履行規劃許可附帶條件（f）項  
提交消防裝置建議

擬在劃為「未決定用途」地帶的  
元朗青山公路 — 元朗段第 115 約地段第 725 號（部分）、  
第 726 號（部分）、第 727 號餘段（部分）、第 729 號、  
第 730 號、第 731 號（部分）、第 758 號（部分）、  
第 759 號（部分）、第 760 號（部分）、  
第 774 號 A 分段（部分）、第 774 號 B 分段及第 775 號（部分）  
經營臨時食肆和商店及服務行業（私家車銷售）（為期三年）  
(規劃申請編號：A/YL-NSW/315)

## **TEMPORARY DRAINAGE PROPOSAL (FINAL)**

**Response to Comments on Temporary Drainage Proposal**

Appendix C -  
 Proposed Drainage Plan

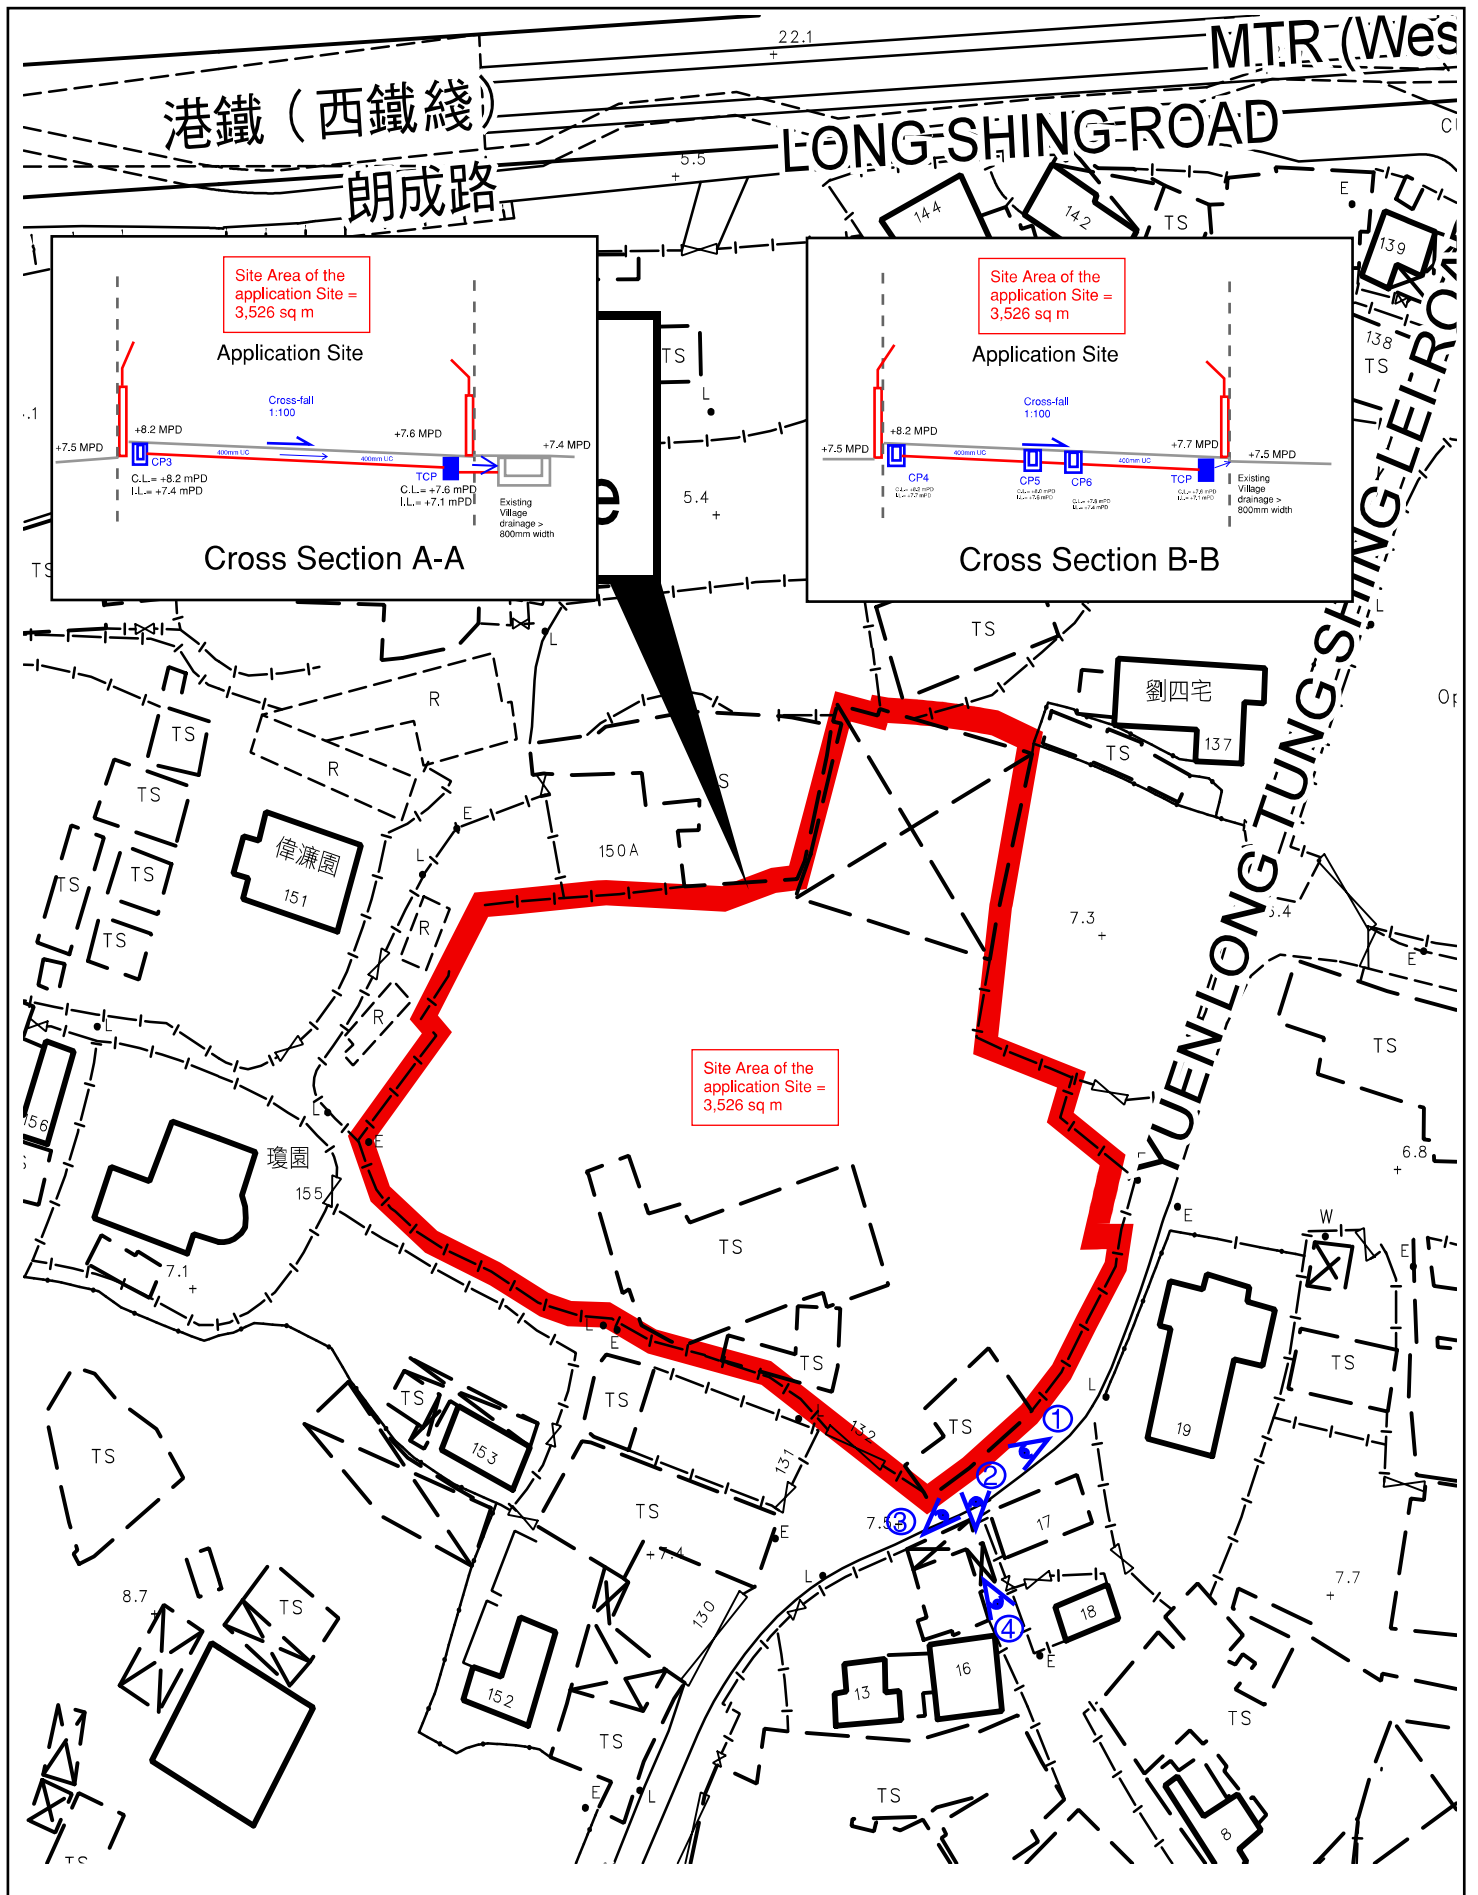
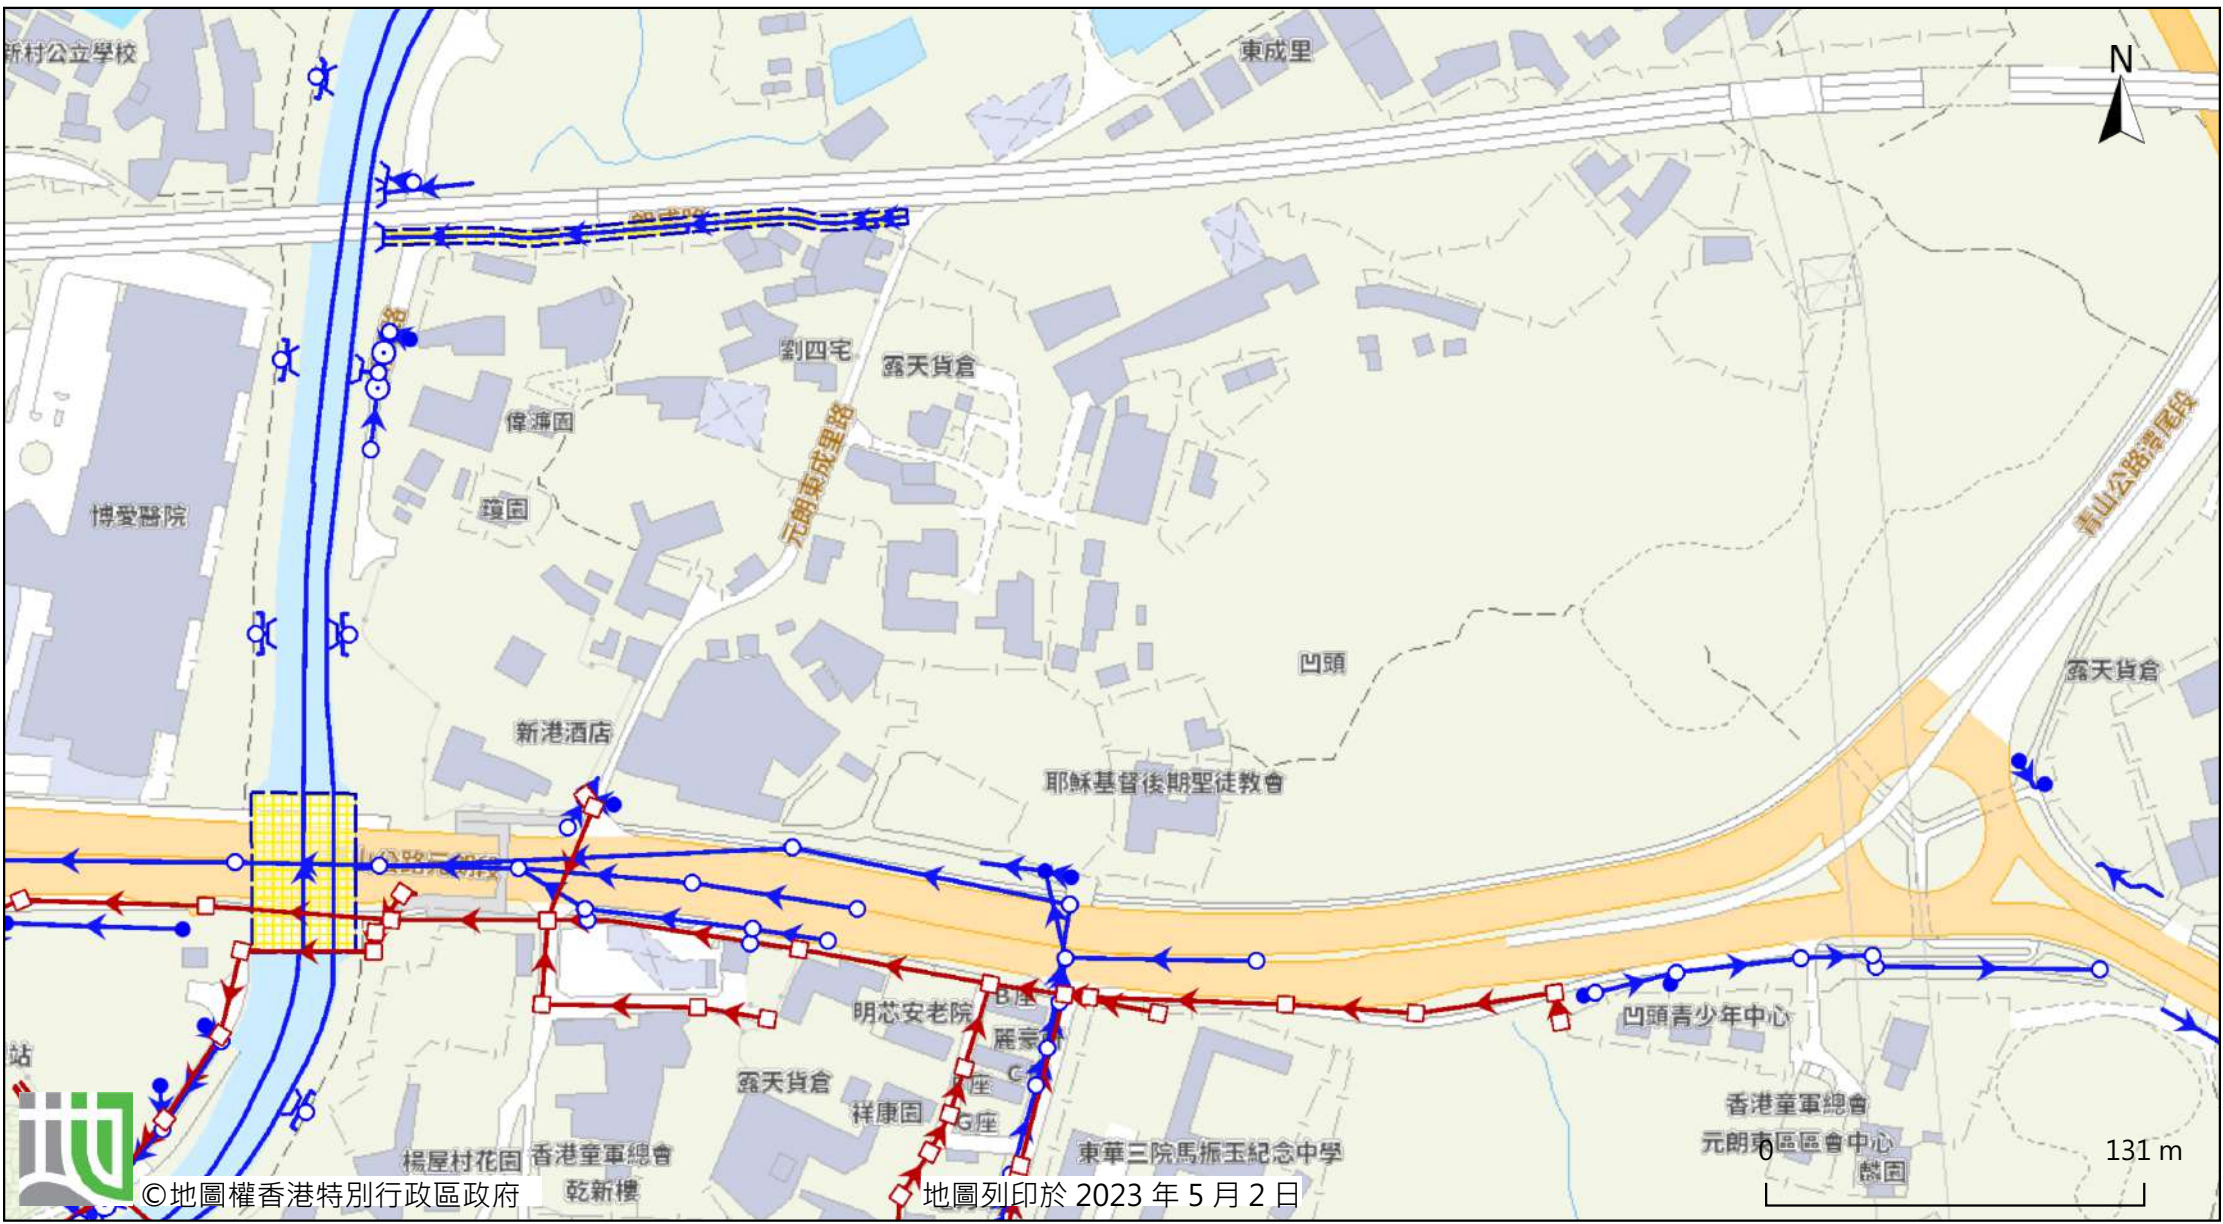
B.	Please clarify the type and size of outlet pipe of TCP as the legend is not consistent. Please revise.	Revised accordingly, a 450mm UC would be connected to the existing village manhole.

C.	Please indicate clearly the full alignment of the discharge path from the application site all the way down to the ultimate discharge point (e.g. a well-established stream course/public drainage system).	The full alignment of the discharge path from the application site is indicated in Appendix C.

E.	The applicant should check and ensure the hydraulic capacity of the existing drainage facilities would not be adversely affected by the captioned development. Please provide site photos covering the whole alignment of existing drainage path to show existing condition of the existing drainage facilities which receives the discharge from the application site.	Noted. The site photos are provided in the Appendix C.

G.	Cross sections showing the existing and proposed ground levels of the captioned site with respect to the adjacent areas should be given.	Cross sections are provided in Appendix C.

3.	Previous comment G has not been fully addressed. Ground levels of application site and adjacent lands should be provided. The cross section should cut through the whole application site with adjacent lands along both east-west and north-south directions. All proposed drainage facilities should be shown in sections. The proposed opening should be indicated in sections.	The sections are provided accordingly.  Please be advised that the submission is just a temporary drainage proposal for applications for S.16. The level of details for the submission are make reference to the Technical Note to prepare a drainage submission by DSD dated November 2001. <a href="https://www.dsd.gov.hk/EN/Files/Technical Manual/dsd guideline/Drainage Submission.pdf">https://www.dsd.gov.hk/EN/Files/Technical Manual/dsd guideline/Drainage Submission.pdf</a>

**APPENDIX D**  
**DESIGN CALCULATION OF THE PROPOSED DRAINAGE**

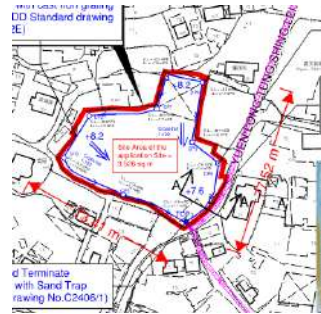
6.	Appendix D The outlet drain stated as pipe does not tally with a proposed UC as shown in drainage plan. Please also review the calculations.	Noted and Appendix D is revised accordingly.
